Seamless Redundancy Issues

Supporting comments on P802.1CB Draft 2.0

October 14, 2015

The issue

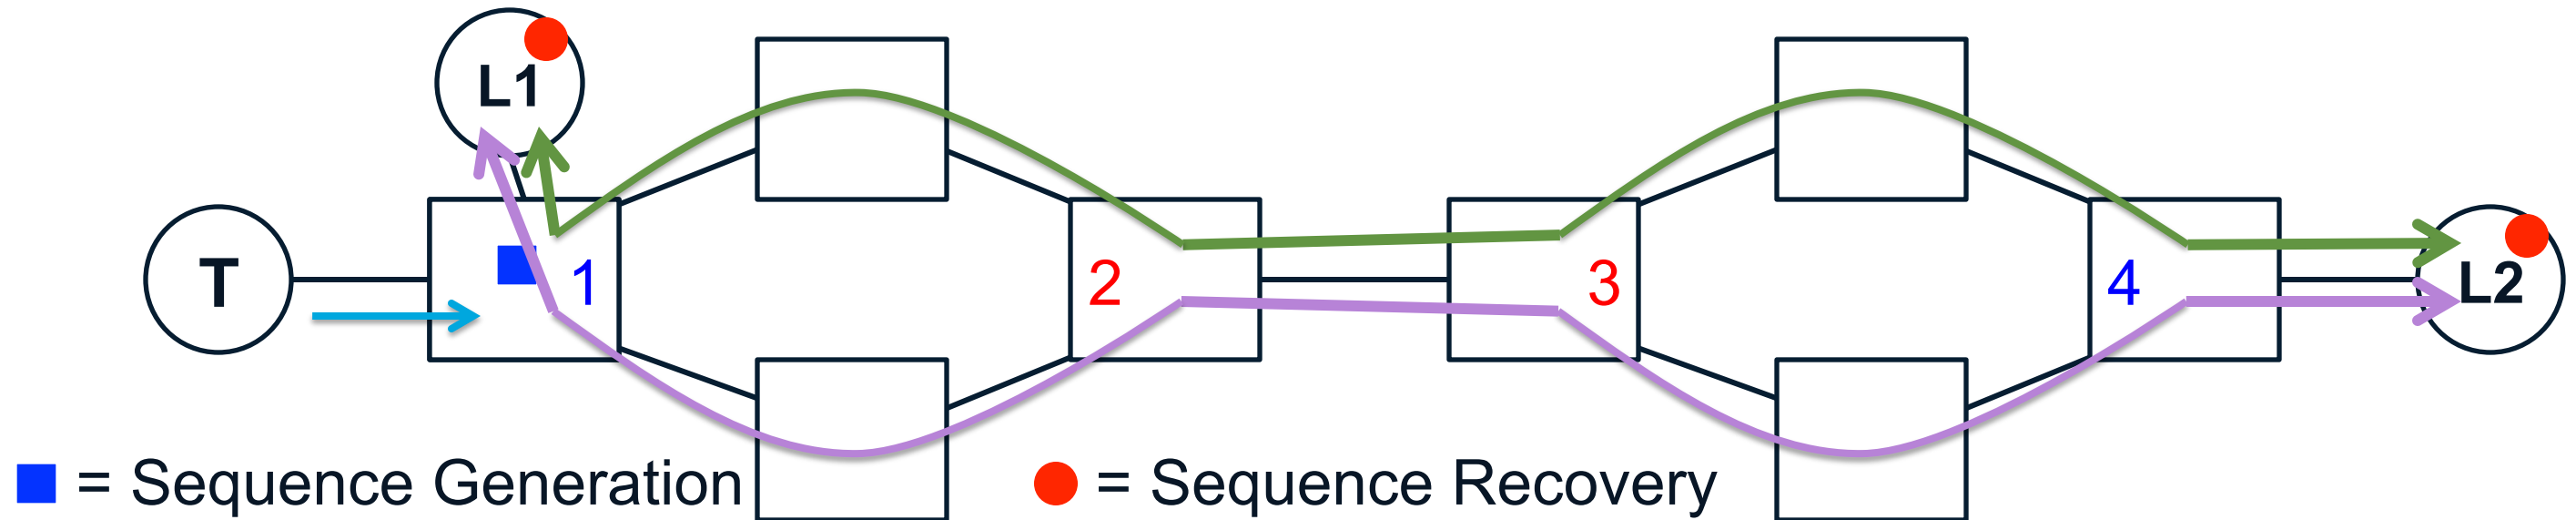
- **Mixed scenario:** Bridge 1 sequences and splits, **both Listeners** expect to merge and recover, and Bridges 2, 3, and 4 simply forward.
- SR is implemented in Bridge 1 and in both Listeners; most of the relay systems and the Talker are SR-unaware.
- **Bridge 1 cannot be configured this way in P802.1CB Draft 2.0.** (See editor's note, P802.1CB D2.0 p82 L26.)

Proposed resolution of Question 1: Allow multiple outputs from one input.

- Allowing this configuration requires replicating two copies of one input packet, perhaps identical, perhaps different, on the same output link.
- Editor recommends that this capability be required, and that the managed objects be altered to support it.
- Working Group conclusion:

Additive delays

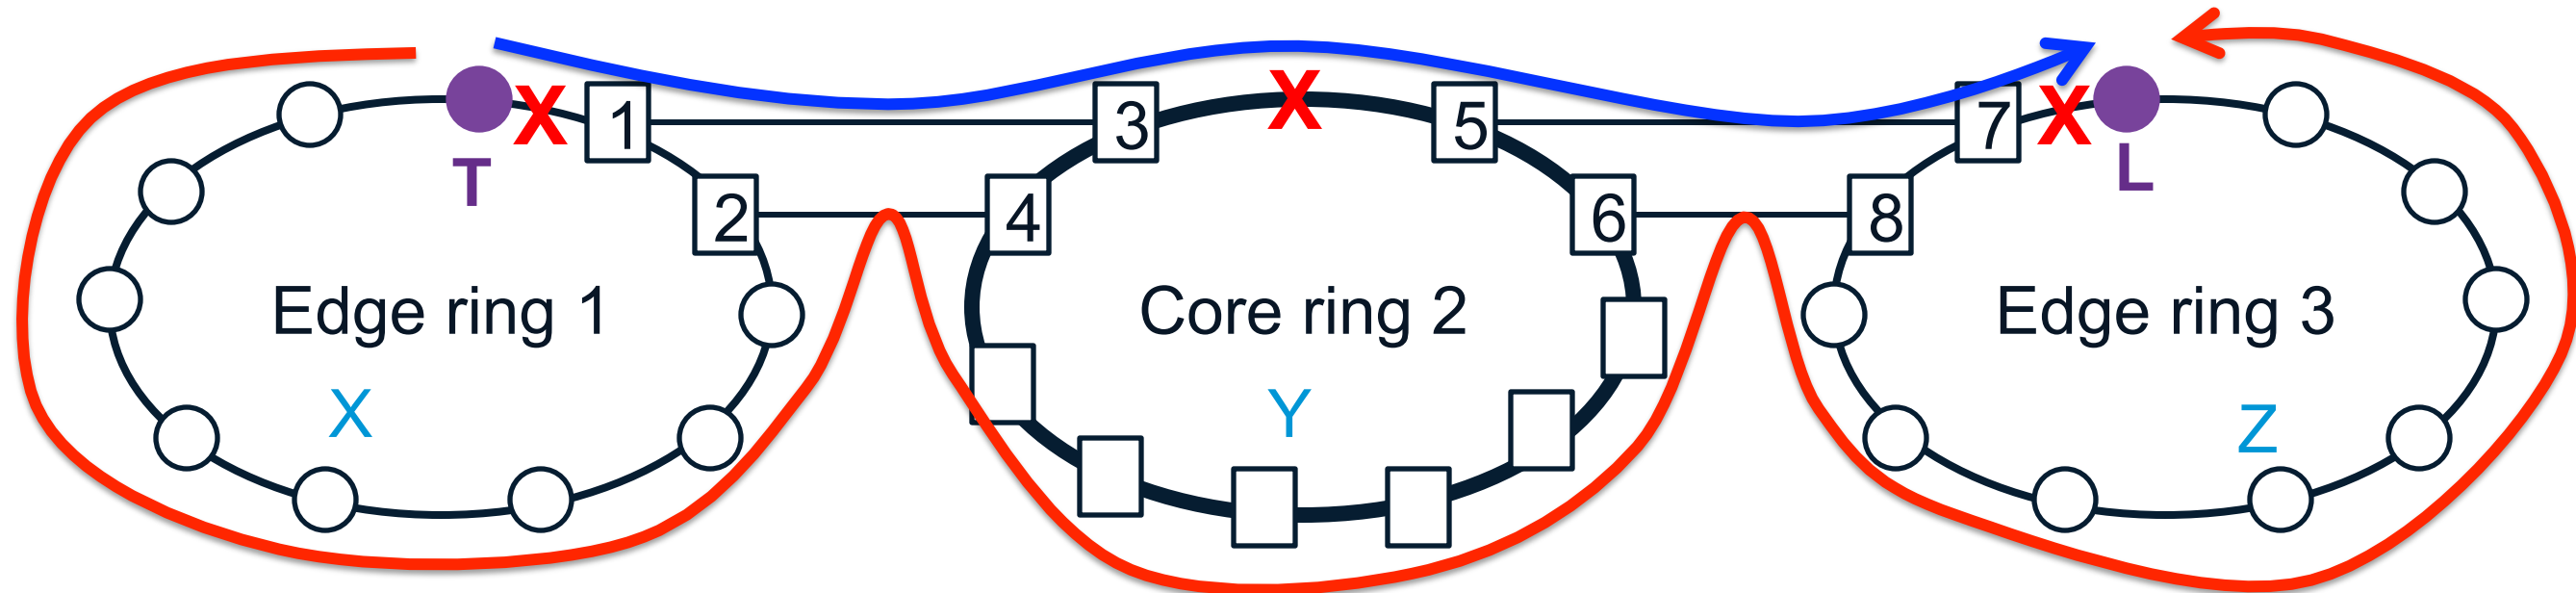
- $\Delta t_1 = t(TX2) - t(T1)$, $\Delta t_2 = t(4Y6) - t(35)$, $\Delta t_3 = t(8ZL) - t(7L)$
- Total delta Talker to Listener $\Delta t_{TL} = \Delta t_1 + \Delta t_2 + \Delta t_3$
- If we're using TSN for zero congestion loss, the **allocated buffer space in every system in Edge ring 3 must account for the total Δt_T** , in addition to the normal requirements for TSN.
- This is nothing for intermittent Streams, but it is **critical for bulk Streams**.

Failure followed by healing

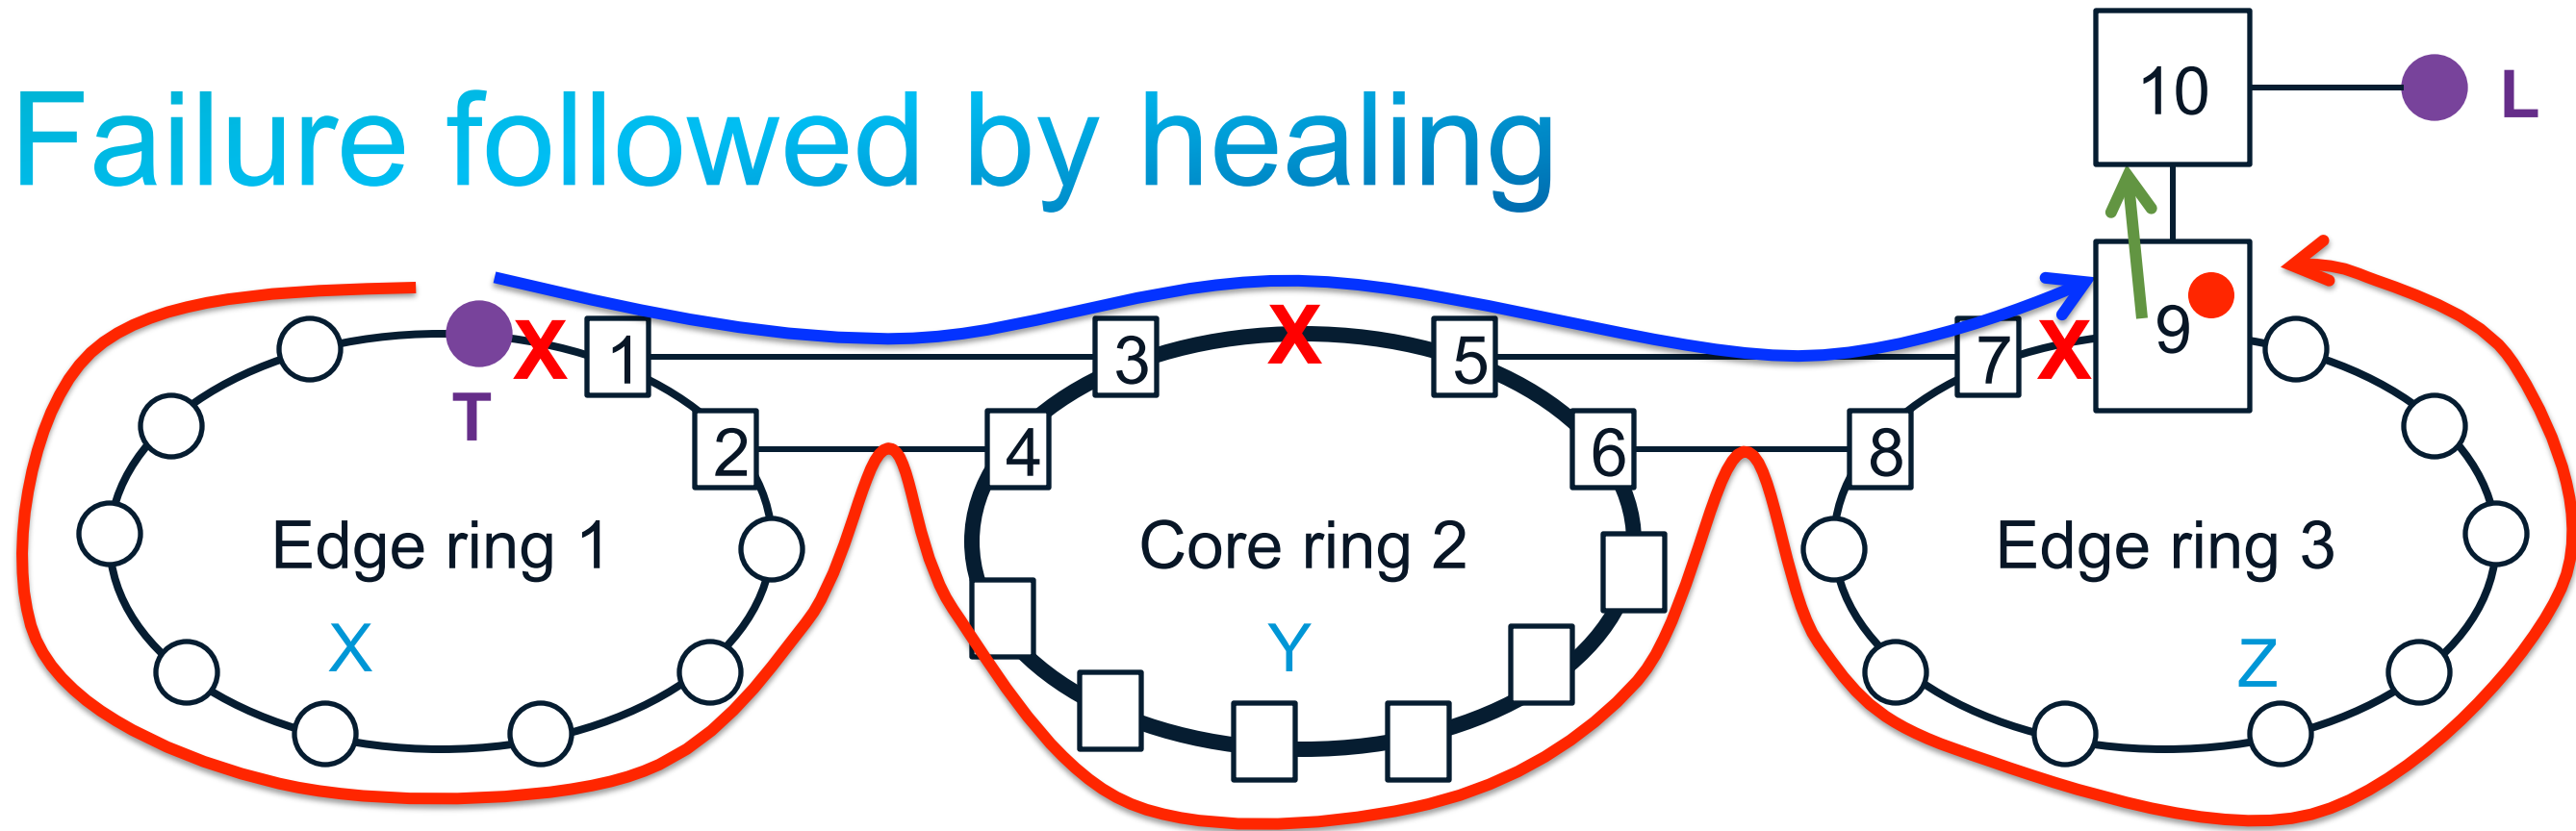
- Let us look at what happens if all three links fail, and then heal, each at the same time. Note that we have added Bridge 9, which performs sequence recovery and sends a single TSN Stream to the Listener via Bridge 10.
- (This is not a silly scenario! Human-induced network management errors and the unfortunate placement of big electric motors are two causes.)
- Remember, we are looking at bulk Streams.

Double rate output after healing

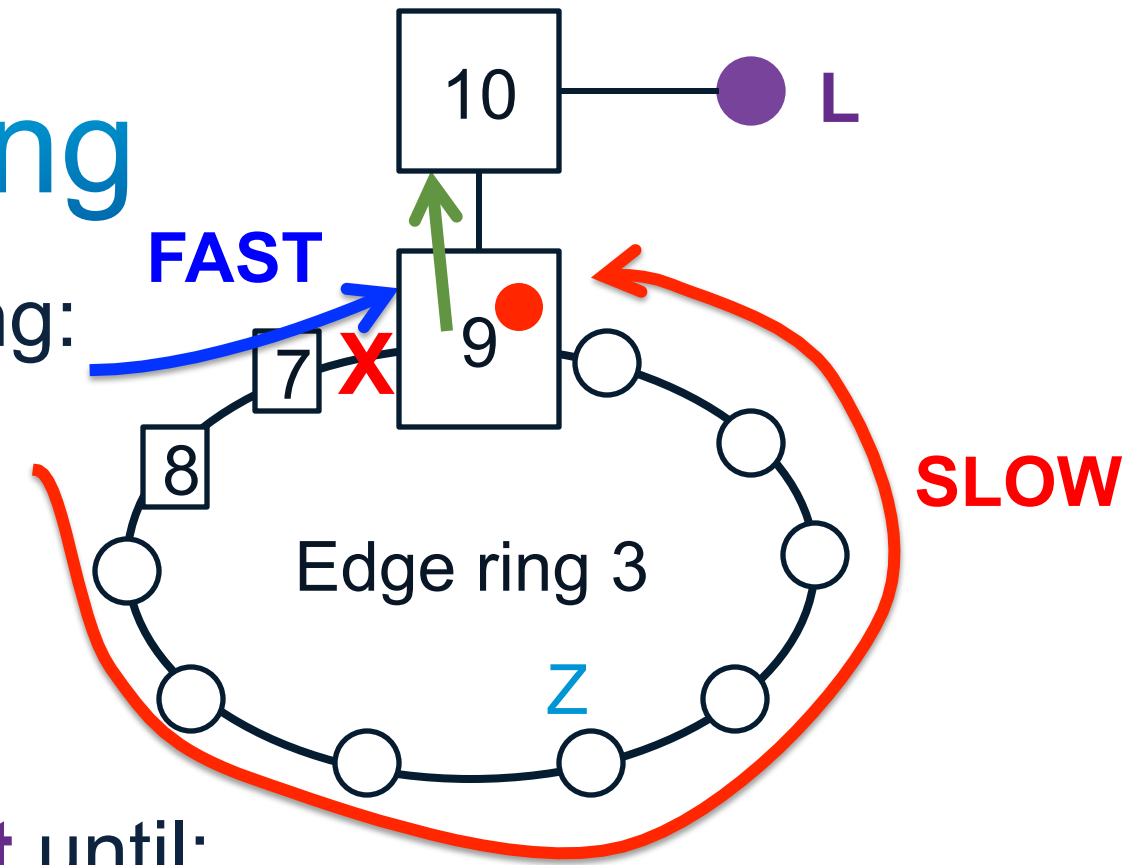
- Network is in steady state. Bridge 9 is receiving: 1040, 1000*, 1041, 1001*, 1042, 1002*, ..., where the **starred packets are discarded**.
- When the **fast links fail**, Bridge 9 receives: 5040, 5000* (fail), 5001*, 5002*, ...
- The discards continue with **no packets output** until: 5038*, 5039*, 5040*, 5041, 5042, 5043, ... Normal output rates resume.
- When the **fast links heal**, Bridge 9 receives: 7998, 7999, (heal) 8040, 8000, 8041, 8001, 8042, 8002, ..., and Bridge 9 **continues double-rate output (or buffering)** until: 8078, 8038, 8079, 8039, 8080, 8040*, 8081, 8041*, 8082, 8042*, ... Normal output rates resume.

Proposed resolution of Question 2: Add Delay Function to P802.1CB

- If the given is that CQF distributes packets from input to output based on time, then the obvious solution is to introduce deliberate timed delay FIFOs at certain points in the network to equalize the path delays.
- One FIFO per group of Streams with the same path deltas is sufficient.
- These delay functions could be specified in P802.1Qch, in P802.1CB, or in some other 802.1Q amendment, but we can observe that:
